# Certificate of Appropriateness

| <b>Property</b>            | 1401 E. BRADY ST.      Brady Street Historic District   |
| <b>Date issued</b>         | 5/9/2017      PTS ID 114276 COA: emergency exit and reinstall previous beer garden  |

1 **SITE PLAN**  
 A1.0 Scale: 3/32" = 1'-0"

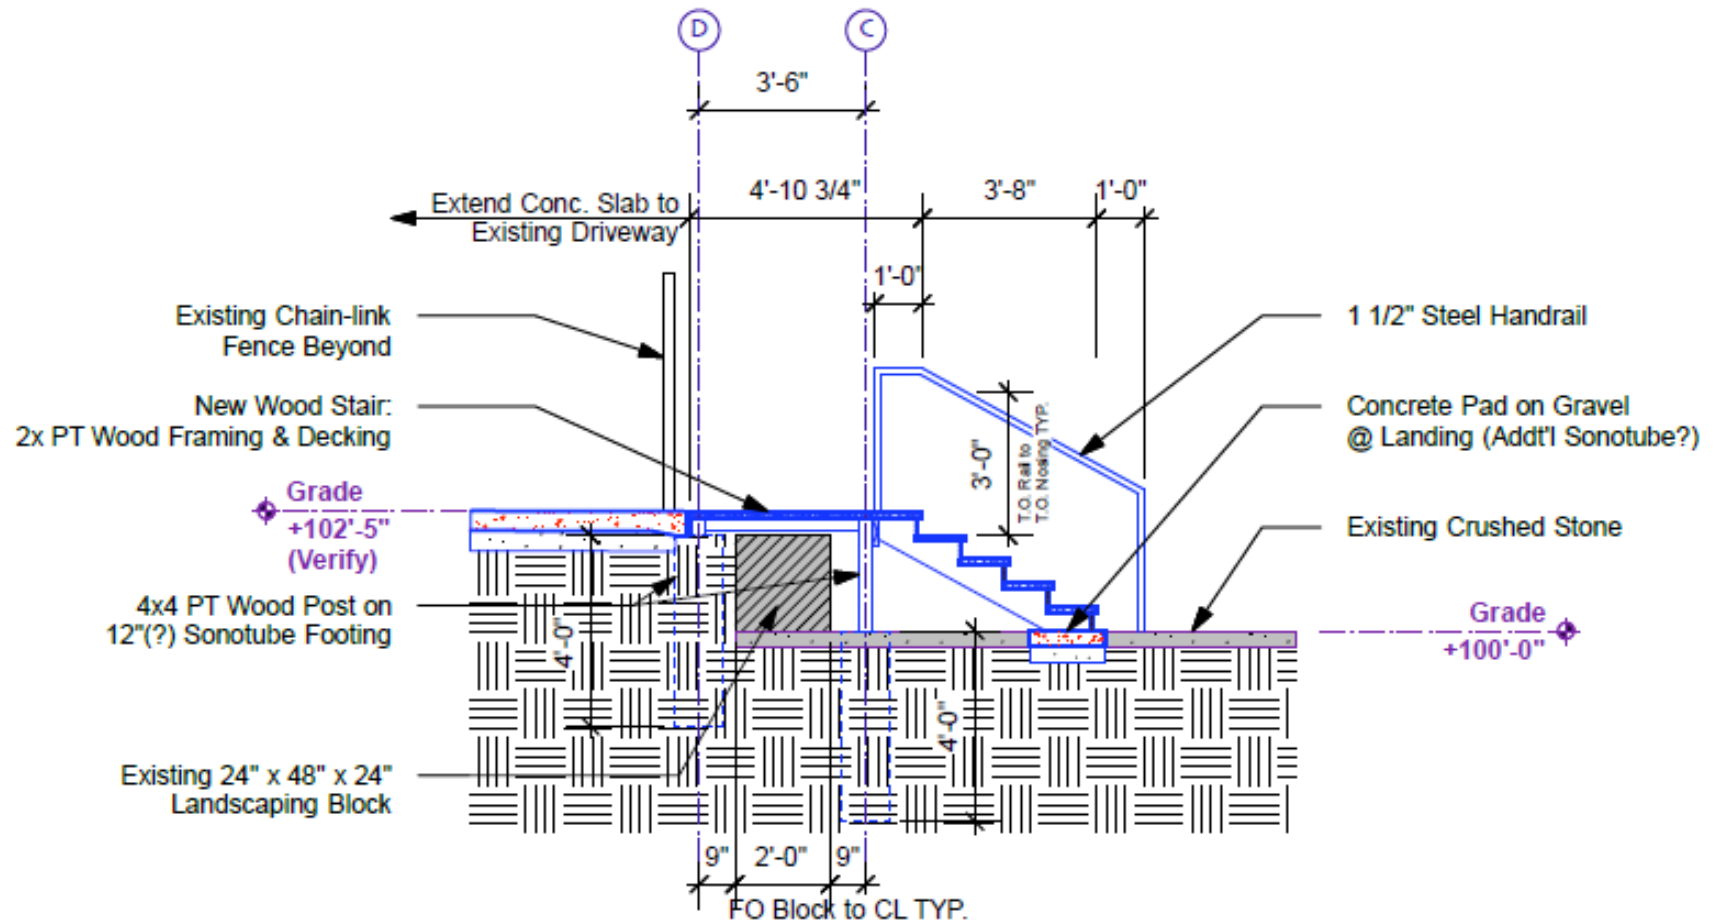
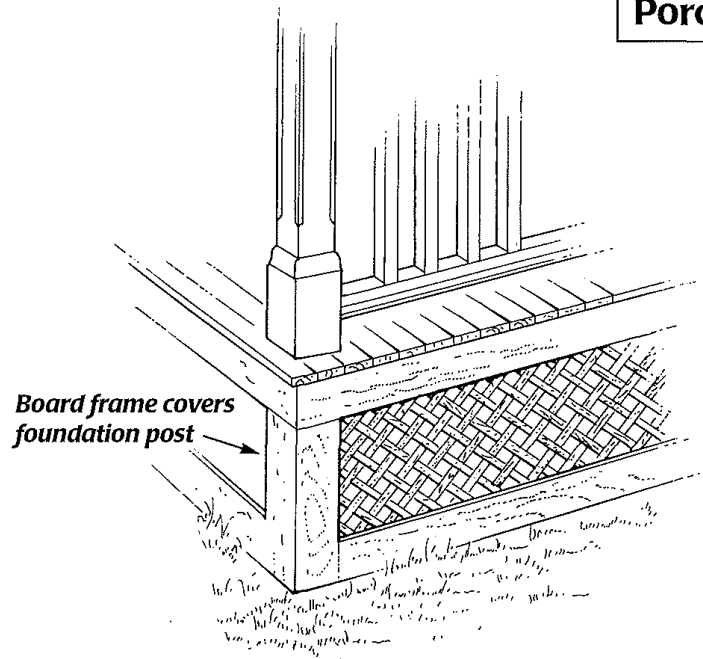
NOTE: Center New Stair @ Existing Opening In Fence  
(Verify Opening Dimension)

- Maximum Tread Rise of New Wood Stair: 7"
- Minimum Tread Run of New Wood Stair: 11"
- Verify Elevation Change from Top Landing to Bottom Landing, if Greater than 30", Guard Rails will also be Required (Currently Only Handrail Shown)

**Because of the uncertain longevity of this project, egress stair at rear must be constructed with clear grain, rot resistant wood that is painted or stained with an opaque stain. Pressured treated lumber cannot be visible and cannot be used for deck, risers, or treads. The only allowed use of PT lumber is for posts up to landing height and only if completely obscured by corner boards. Corner boards and skirting are required, see examples below. Metal rail must be painted or powder-coated.**

## Porch Skirting

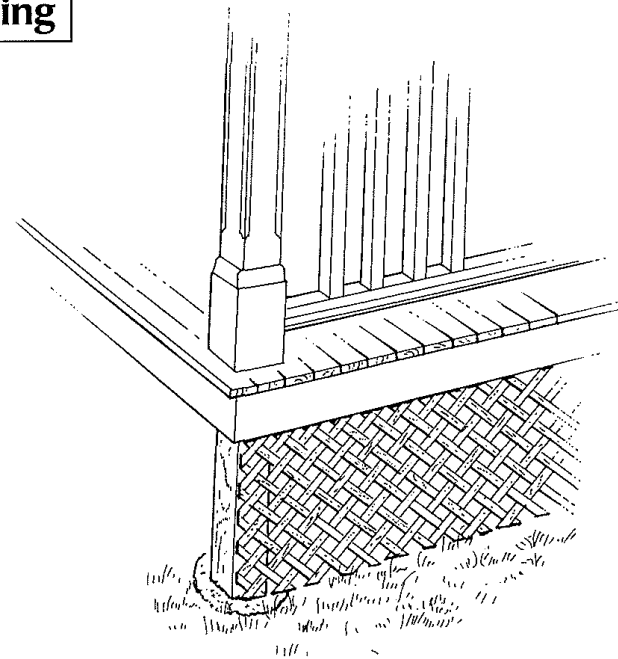
*Do not install a lattice skirting without a frame around it. The rough framing lumber that supports the porch will show through and the raw edges of the lattice look unfinished.*
